**RE: W.O. 22-: West End Intake/Pump Station  
City of Billings Public Works Department, Billings, Montana**

**ADDENDUM NO. 3**  
**TO**  
**CONTRACT DOCUMENTS AND SPECIFICATIONS**  
**FOR**  
**W.O. 22-19, WEST END WATER INTAKE/PUMP STATION**  
**FOR**  
**CITY OF BILLINGS, MONTANA**  
**PUBLIC WORKS DEPARTMENT**

Date: November 2, 2022

SHEET  
**00C008**

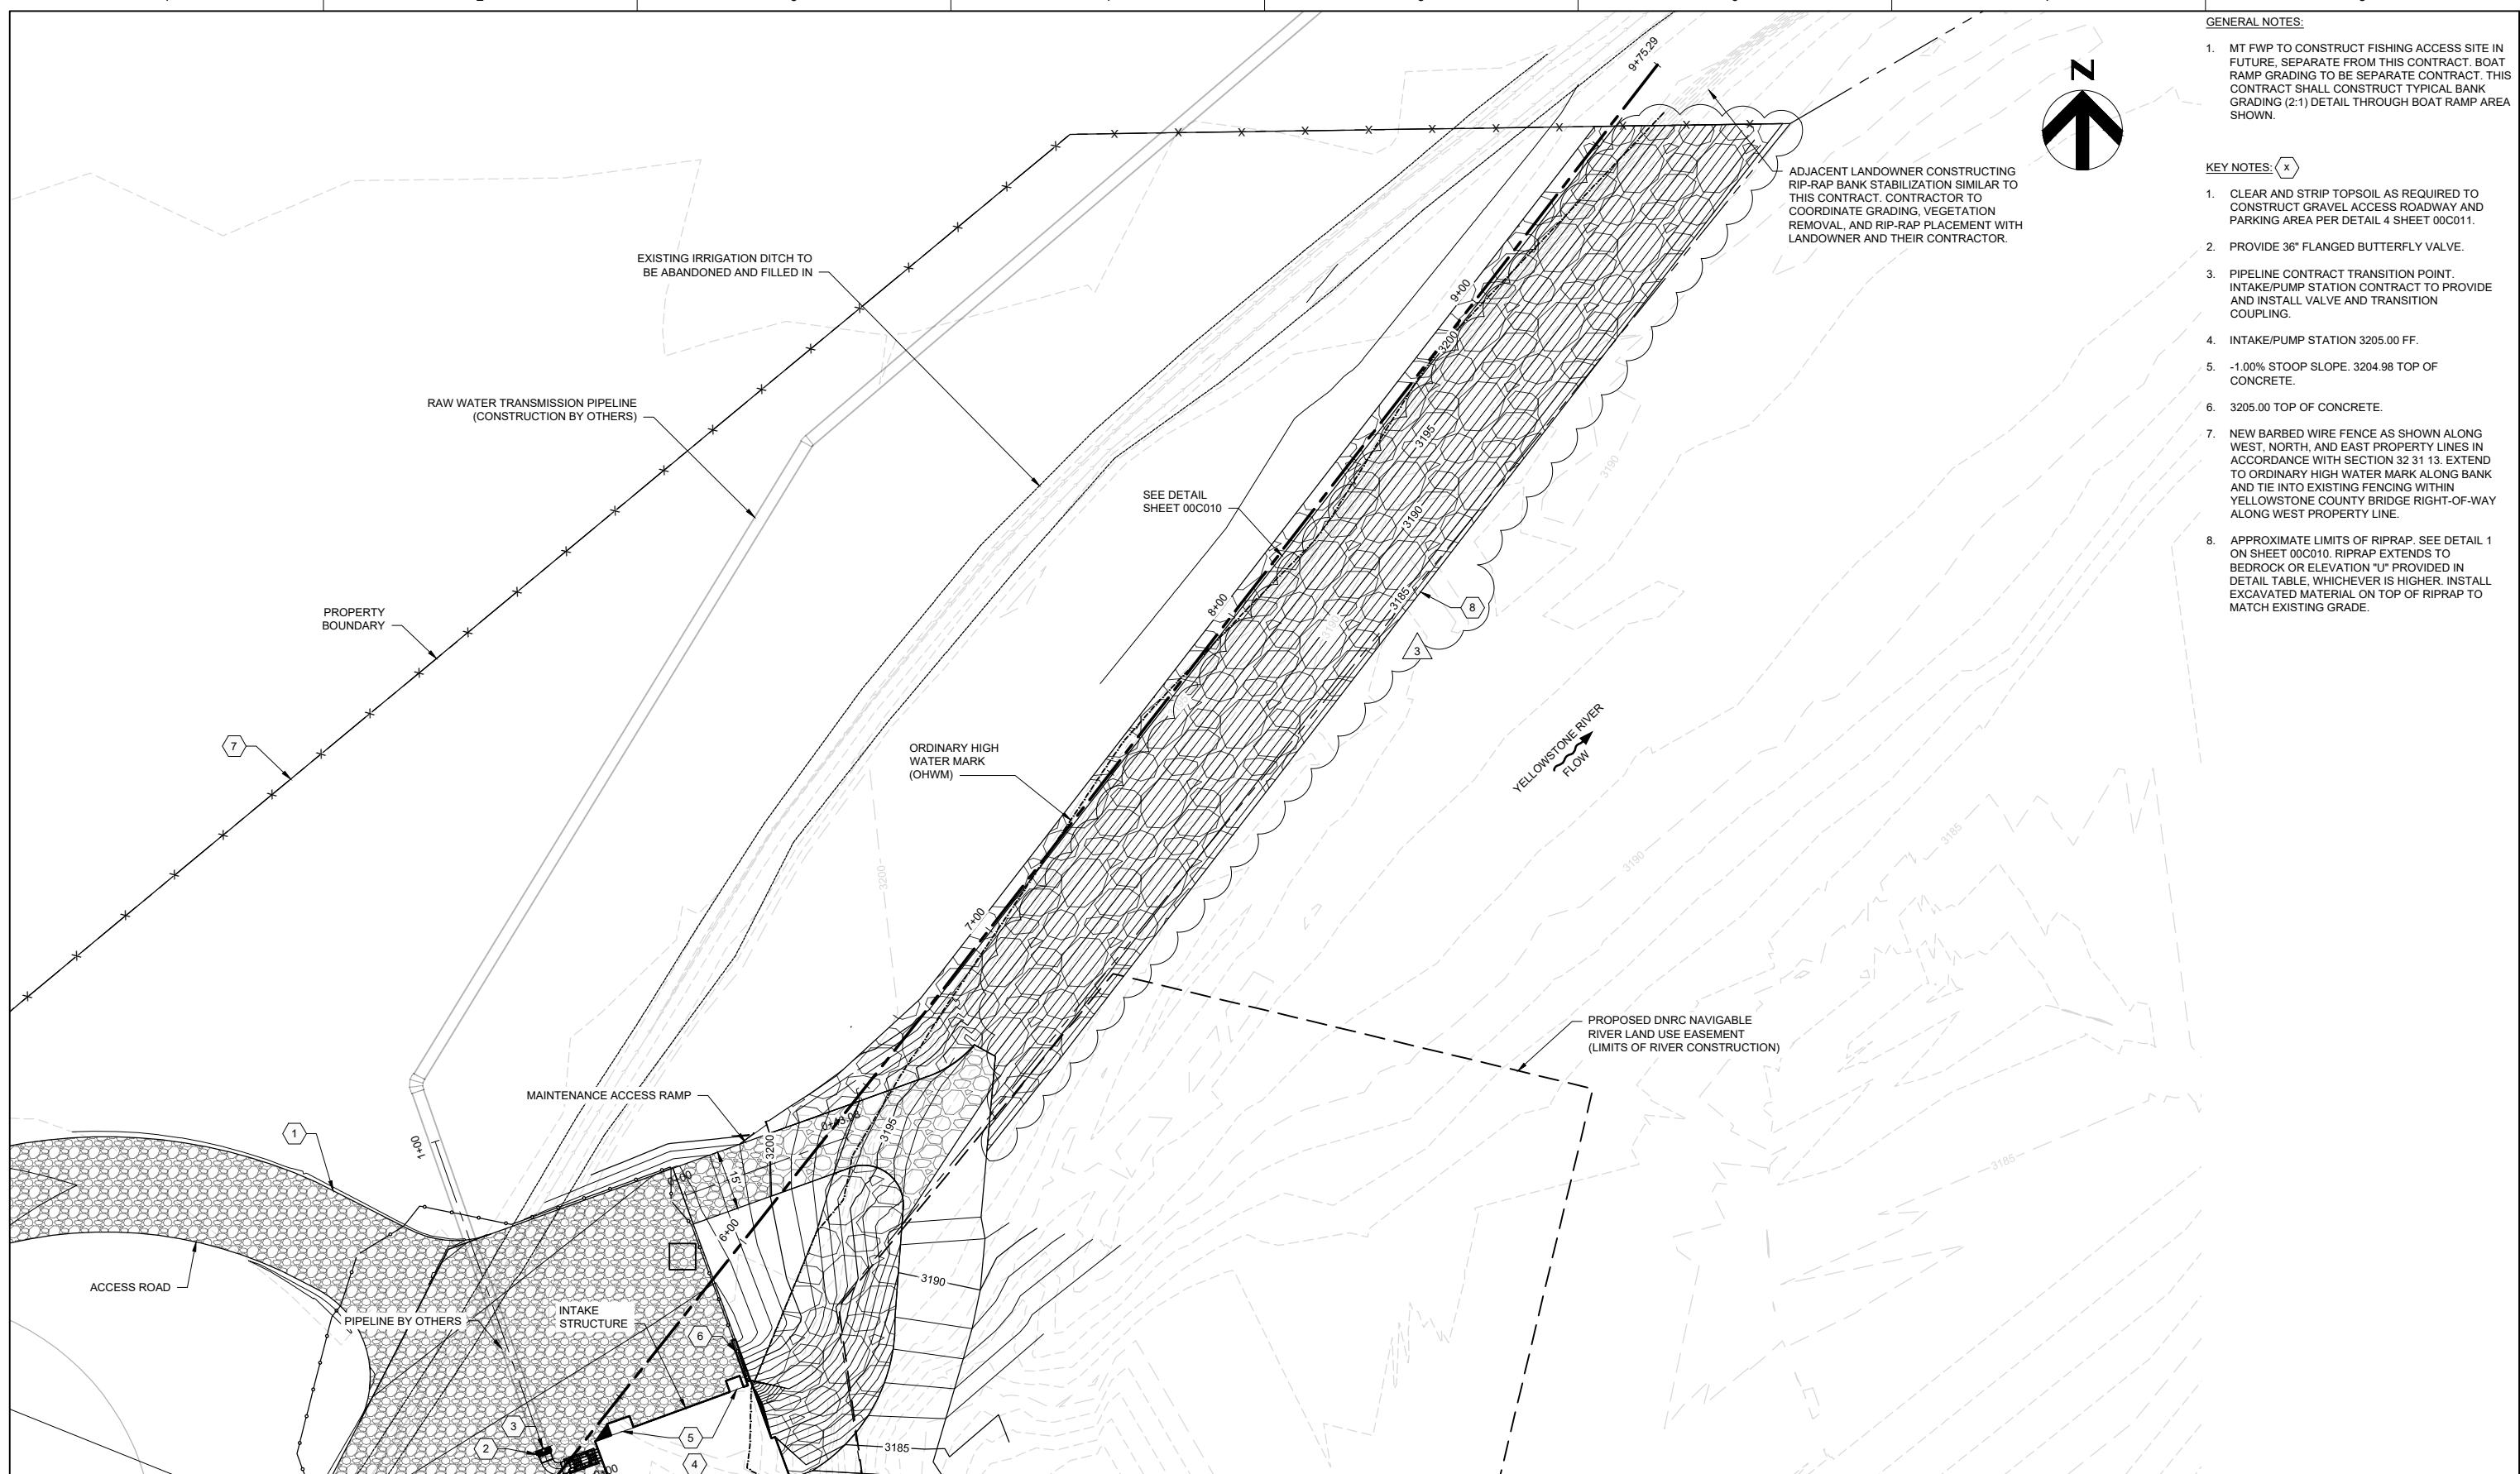
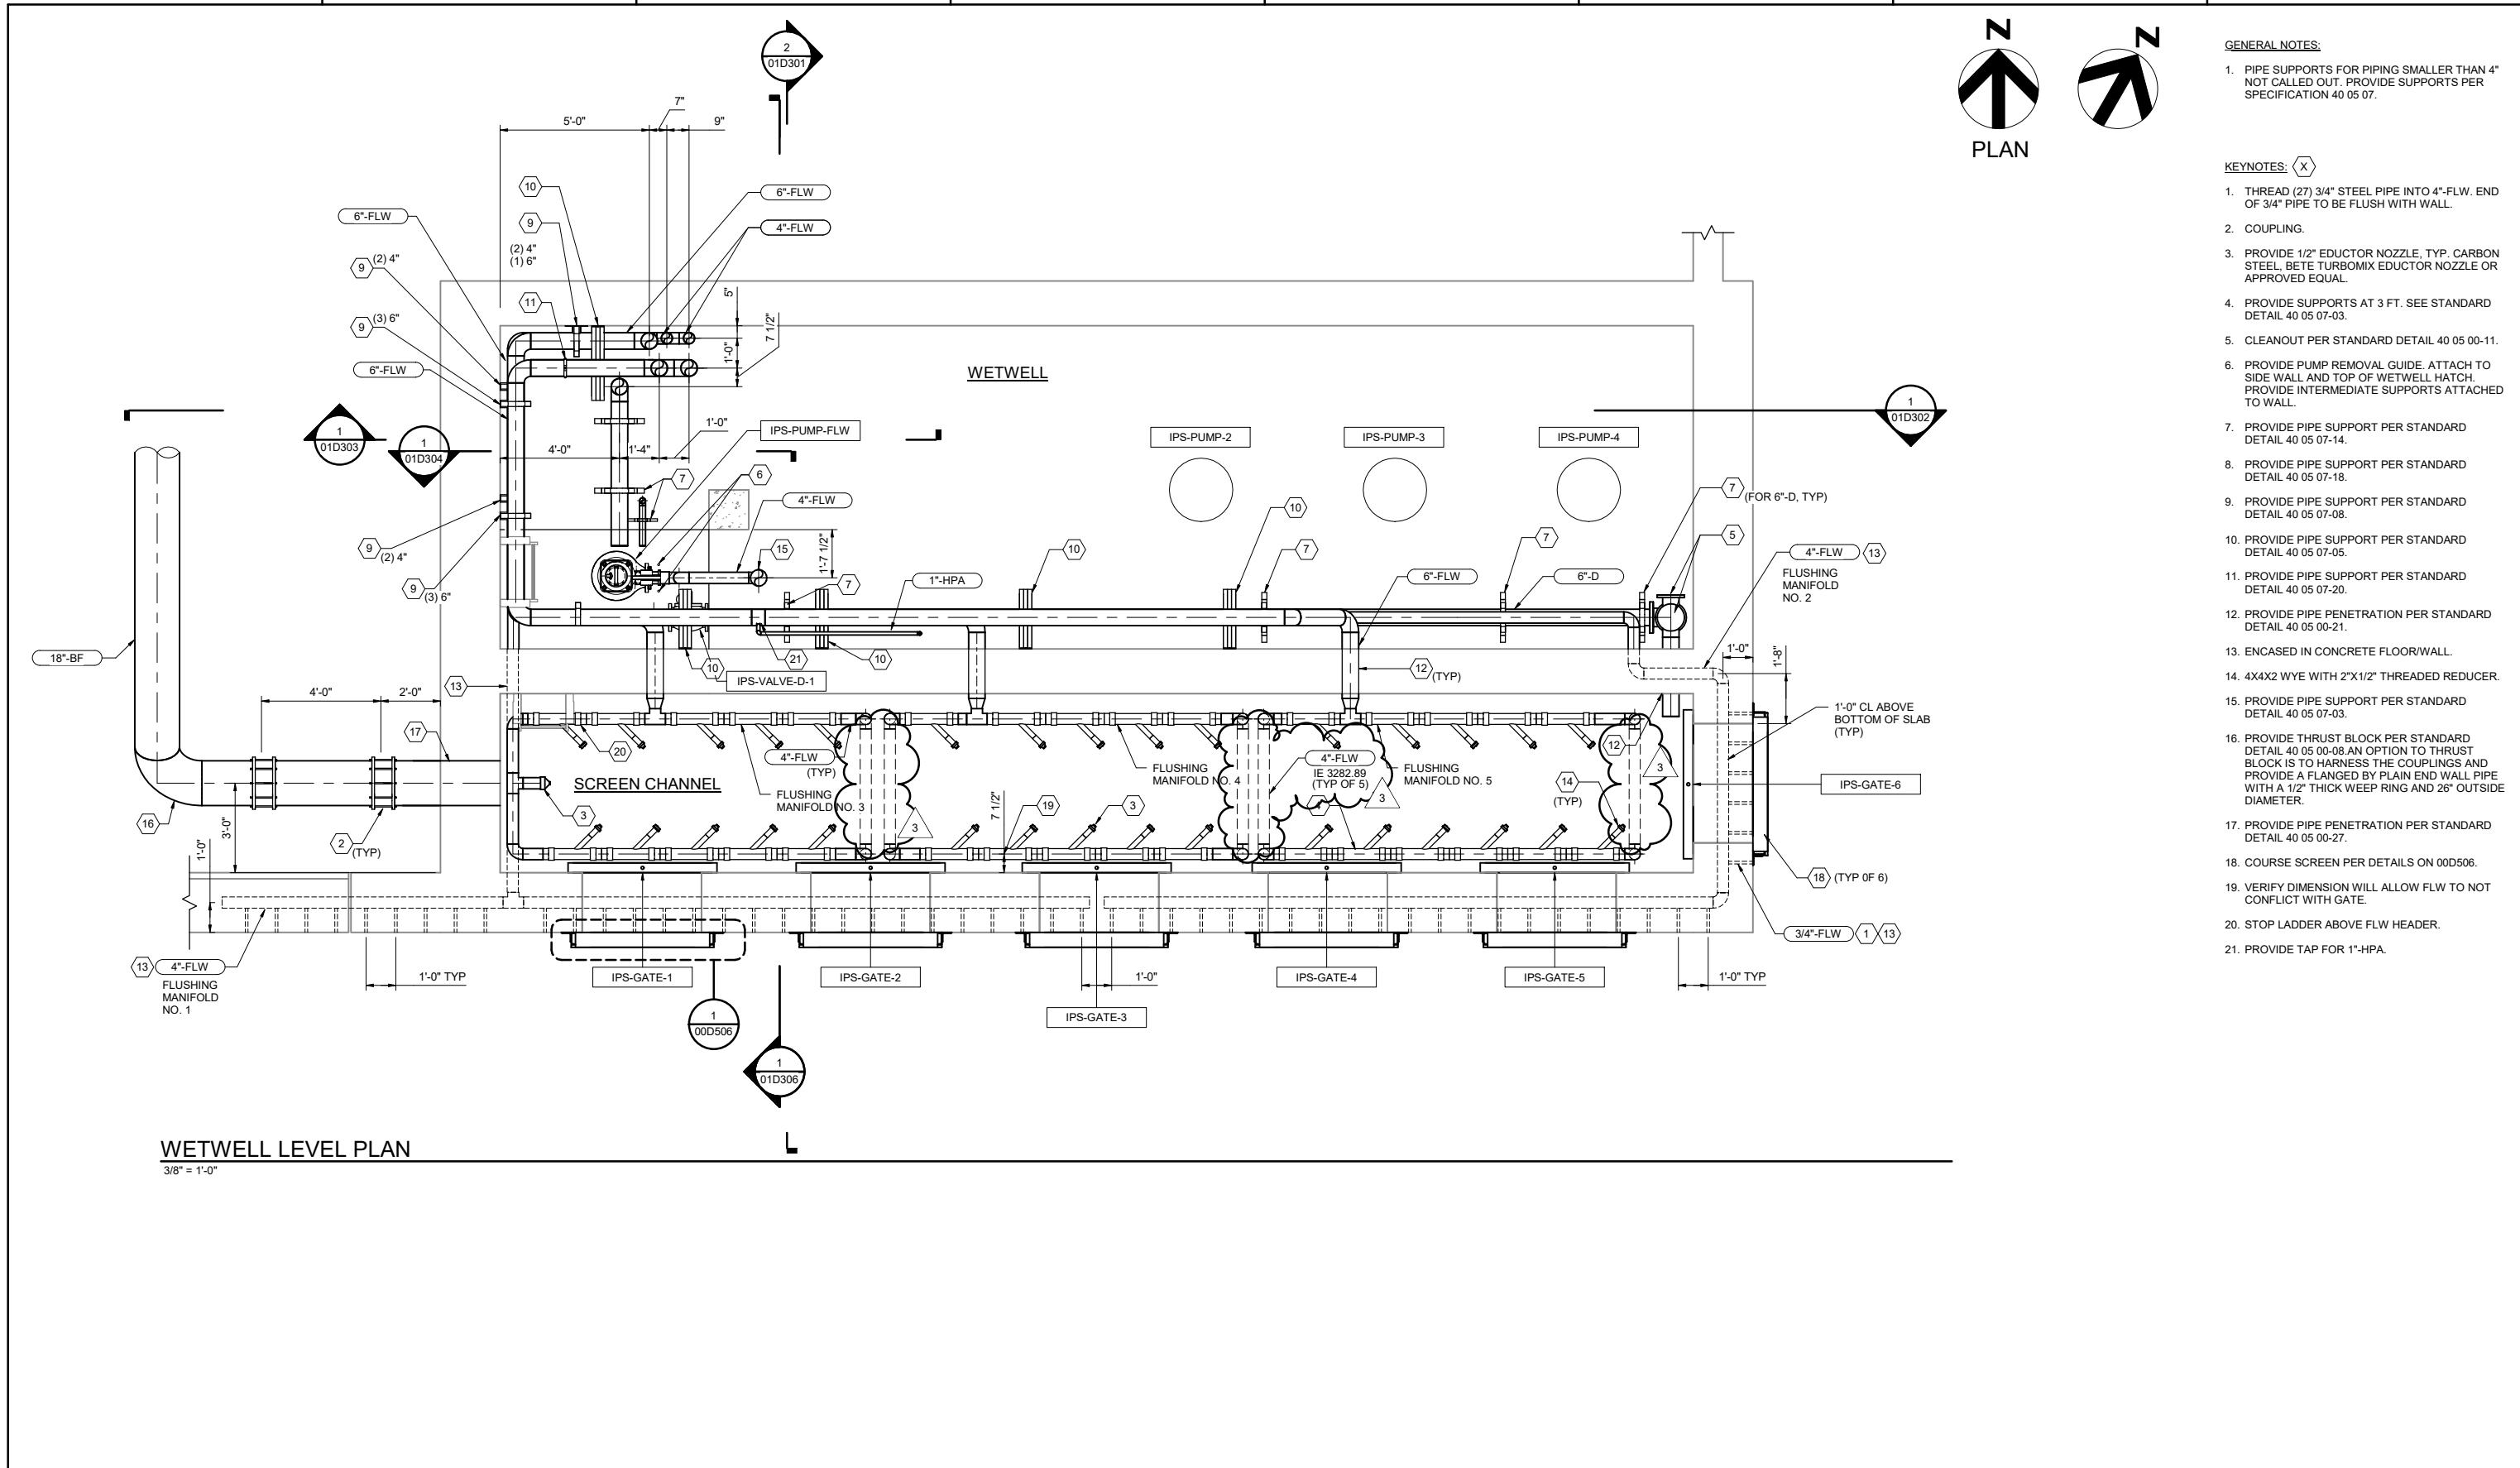
AD-3 Item 17. Sheet 00C008. DELETE this sheet in its entirety and REPLACE with the attached sheet.
